Expert Opinion

Amendment C339ggee Part 2: Flood Controls to the Greater Geelong Planning Scheme

City of Greater Geelong

| Title: | Expert Opinion Amendment C339 to the Greater Geelong Planning Scheme |

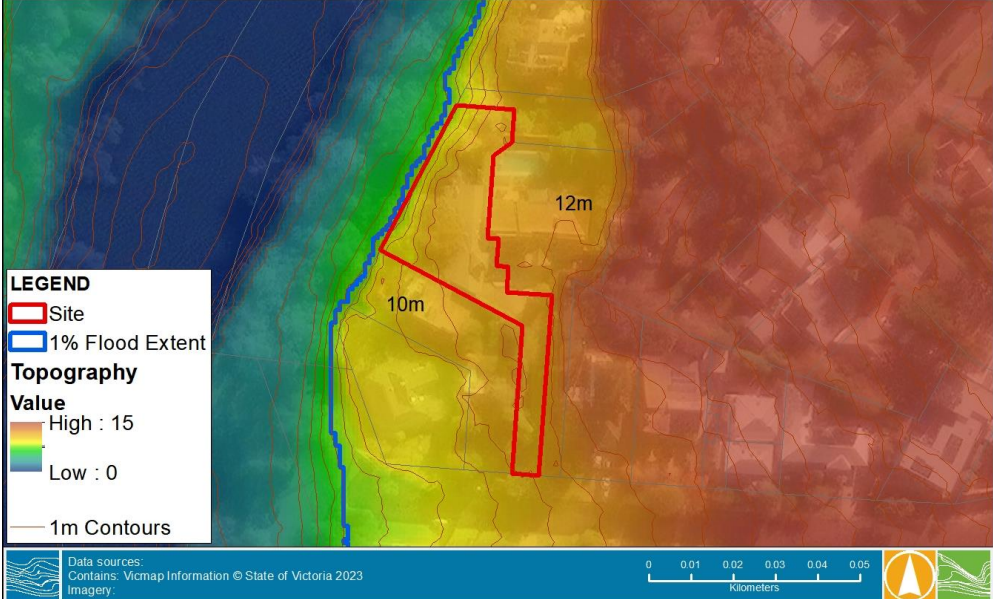
| Concerns Raised | Comments |
|---|--|
| <p>Submission 440 – 32 Monier Way, Fyansford .</p> | <p>The Lower Barwon and Lower Moorabool Flood Study was based on topographic data collected in January 2017. At this time the “Gen Fyansford” estate had commenced earthworks but extensive filling of this area had not been completed. The 1% AEP flood level and corresponding flood extent on which the Land Subject to Inundation Overlay is based is around 8.15 m AHD in this area. It is understood that ground levels within the lowest sections of the estate have now been raised. Approved plans provided to council indicate that ground levels within Monier Way and the sections shown to be flooded in the exhibited C339 overlay have been raised to 9.3 – 9.6 metres AHD along Monier Way.</p> <p>The figure below shows a side-by-side comparison of the existing and flood-study topography, highlighted where the lots have been filled.</p> <p>The Gen Fyansford land levels are now higher than the applicable flood level and the associated residential lots would not be subject to inundation in a 1% AEP design flood. It is therefore recommended that the overlay maps be clipped to the extent of filling within this area of development.</p>  <p>Legend Topography (m AHD) High : 17.615 Low : 1.105</p> <p>Existing Topography January 2017 Model Topography</p> <p>Data sources: City of Greater Geelong Contains: Vicmap Information © State of Victoria 2020 Imagery: Geelong Imagery 01 OCT 2019</p> <p>28/02/2022</p> |

Submission 562 - 40-70 Windsor Road, Newtown.

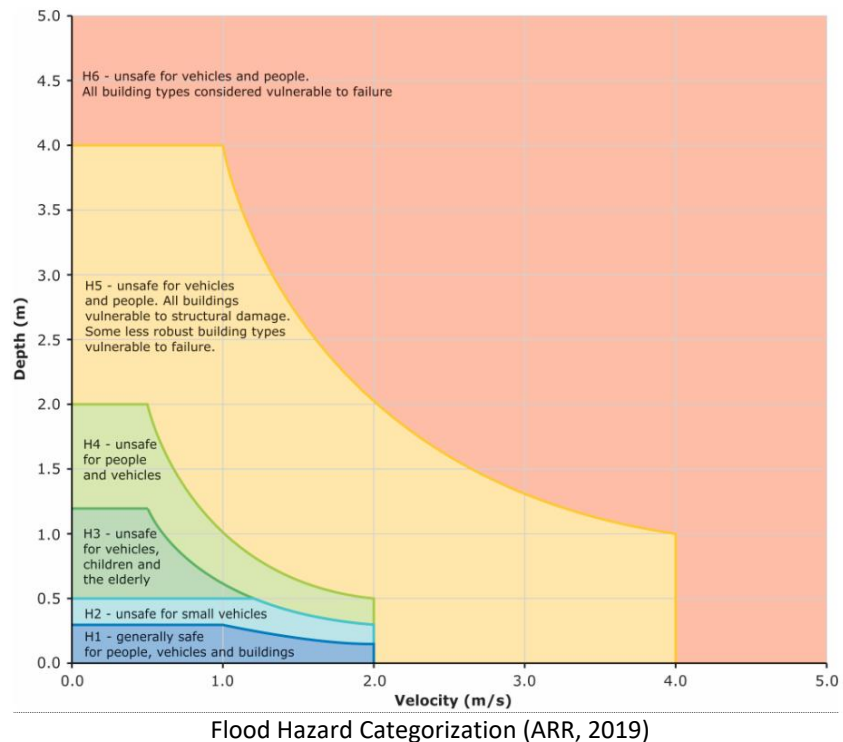
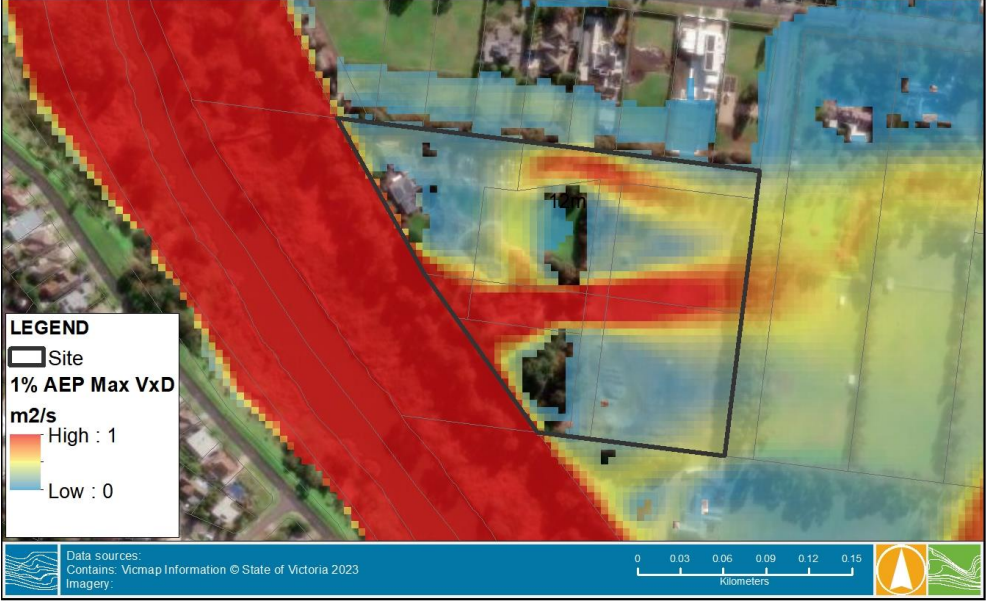
The application of the FO1 as proposed would prohibit any future subdivision of the land, which is considered unduly restrictive. Key concerns include:

- The potential technical discrepancies, as per Lara flood study
- The disparity between evidence identifying the site as an area of flood fringe in c.1998 and the new interpretation of data which categorises it as a high risk floodway, noting that the 1% AEP from the previous studies is essentially the same.
- The discrepancy between the proposed reduction in extent of the LSIO immediately to the north of the subject site and the proposed introduction of the FO1, indicating a higher flood risk to the submitter.

Concerns raised in relation to the potential technical deficiencies in relation to the study as per the Lara Flood Study are not well founded. The Lara Flood Study was not abandoned. Rather, the Lara portion of amendment C339 was abandoned primarily due to challenges with the community engagement related to the number of properties impacted by flooding in that area. The Lower Barwon and Lower Moorabool Flood Study is an independent study that has been peer reviewed and applies a methodology which is consistent with industry best practice. It is endorsed by the CCMA and Council and is entirely appropriate and fit-for-purpose to inform flood-related planning overlays.

The Lower Barwon and Lower Moorabool River Flood Study is considered to be the best available flood information for the Barwon River. This information supersedes previous studies, mapping and advice including any definition of flood fringe from 1998. The definitions under which flood overlays define high risk areas have changed since 1998. Current delineation of FO and LSIO relies on the use of updated hazard criteria which was revised as part of the update to Australian Rainfall and Runoff Guide to Flood Estimation in 2019. The hazard categorisations establish thresholds related to vulnerability (see figure below). These thresholds are determined based on both depth and velocity of floodwaters. Within this amendment the H1 category has been used to define the LSIO areas, with the FO based on flood hazard categories H2 and above. This approach is accepted and used by several Catchment Management Authorities and Councils. The Figure below shows mapped hazard across the site which highlights the significant flood conveyance through the property related to the floodway classification.

Available 1% AEP flood information for the subject property at 40-70 Windsor Road, Newtown indicates that flood depths range between 0 and 2+ metres, with much of the site and its access inundated by depths above 1.0 metre. Modelled peak flood flow velocity varies across the site, with most areas experiencing velocities of less than 1m/s under 1% AEP design flood conditions.

The change (reduction) in flood classification to the north is not a discrepancy. This is related to permitted filling of this part of the floodplain which occurred in the last 20 years. It is desirable that current flood studies and mapping take into present conditions that reflect the current flood risk in order to best inform future floodplain management.
